Fox Run Neighborhood 3 JSP18-18

Public hearing at the request of Erickson Living for Planning Commission's recommendation to the City Council of a Revised Preliminary Site Plan with a PD-1 Option, Revised Special Land Use Permit, Revised Phasing Plan, Revised Wetland Permit, Revised Woodland Permit and Revised Stormwater Management Plan approval. The subject property is 102.8 acres in Section 1 of the City of Novi, located north of Thirteen Mile Road and west of M-5 in the RM-1, Low Density Low-Rise Multiple-Family District. The applicant is proposing to revise the original approval and layout of Neighborhood/Phase 3 of the Fox Run Community.

Fox Run Neighborhood 3
Revised Preliminary Site Plan
JSP18-18

Review Date: February 11, 2019
Review Type: Revised Preliminary Site Plan
Project Name: JSP18-18 Fox Run Neighborhood 3
Location: North of Thirteen Mile Road, West of M-5
Plan Date: 1-15-19
Prepared by: Lindsay Bell, Planner
E-mail: lbell@cityofnovi.org; **Phone:** (248) 347-0484

Figure 1. City of Novi Regulated Wetland & Woodland Map (approximate project boundary shown in red). Regulated Woodland areas are shown in green and Regulated Wetland areas are shown in blue.

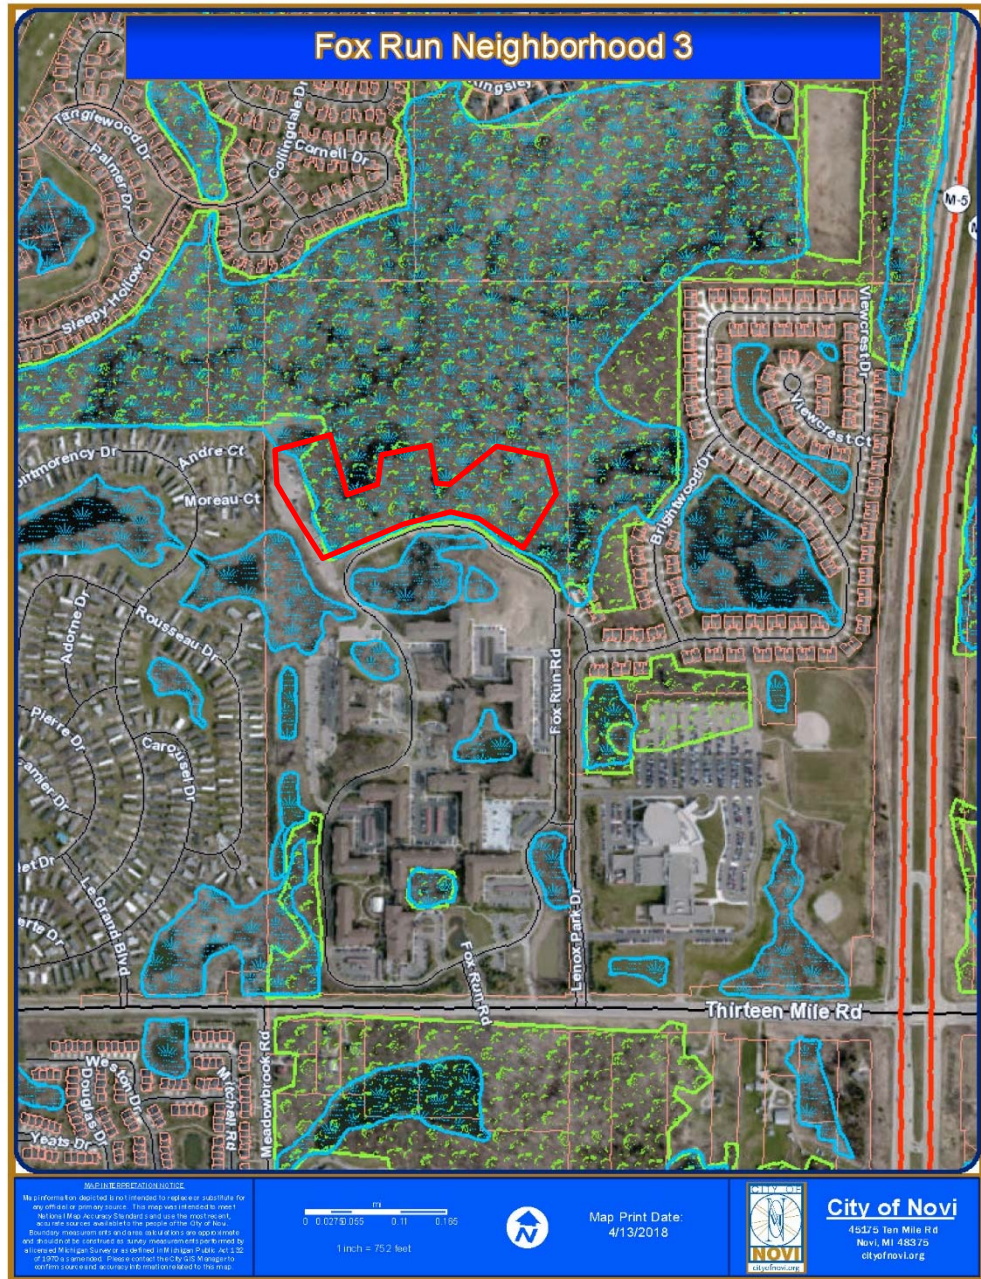
Attachments: Figure 1 – City of Novi Regulated Wetland and Woodland Map
Site Photos

RB 3.1

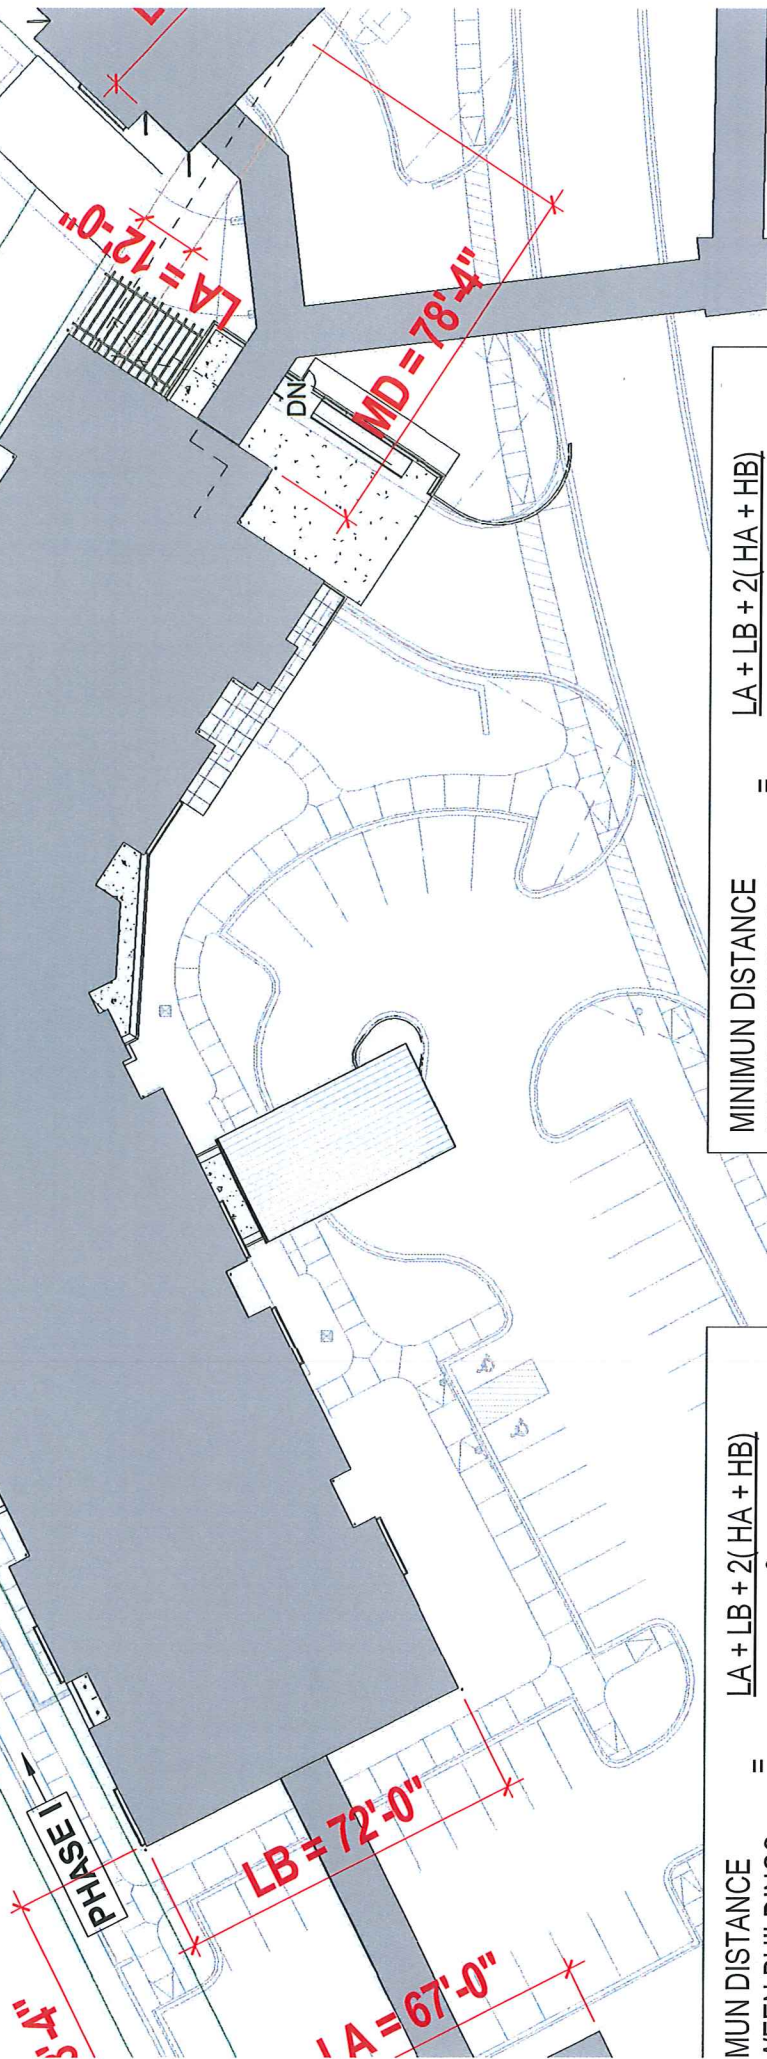
4. Minimum Distance Between Buildings (Sec. 3.8.2.H.): The ordinance provides a formula based on width and height for a minimum distance between two residential buildings in the RM-1 and RM-2 districts. **Using the formula, staff calculates the minimum required distance between RB3.1 and RB3.3 is 81.7 feet. The site plan shows a proposed distance of 77 feet. The applicant should revise the plans to meet the minimum distance or request a variance from City Council.**

Please refer to enclosed sheet PSP-001, which shows that the current proposed design is within the compliance of distances and spacing per 3.8.2.H of the Zoning ordinance.

$$\begin{aligned} \text{MINIMUM DISTANCE BETWEEN BUILDINGS} &= \frac{LA + LB + 2(HA + HB)}{6} \\ \text{MINIMUM DISTANCE BETWEEN BUILDINGS} &= \frac{12'-0" + 72'-0" + 2(90'-1" + 87'-1")}{6} \\ \text{MINIMUM DISTANCE BETWEEN BUILDINGS} &= 73'-0 \frac{1}{2}" \end{aligned}$$

$$\begin{aligned} \text{MUN DISTANCE WEEN BUILDINGS} &= \frac{LA + LB + 2(HA + HB)}{6} \\ \text{MUN DISTANCE WEEN BUILDINGS} &= \frac{67'-0" + 72'-0" + 2(90'-1" + 89'-1")}{6} \\ \text{MUN DISTANCE WEEN BUILDINGS} &= 82'-1" \end{aligned}$$
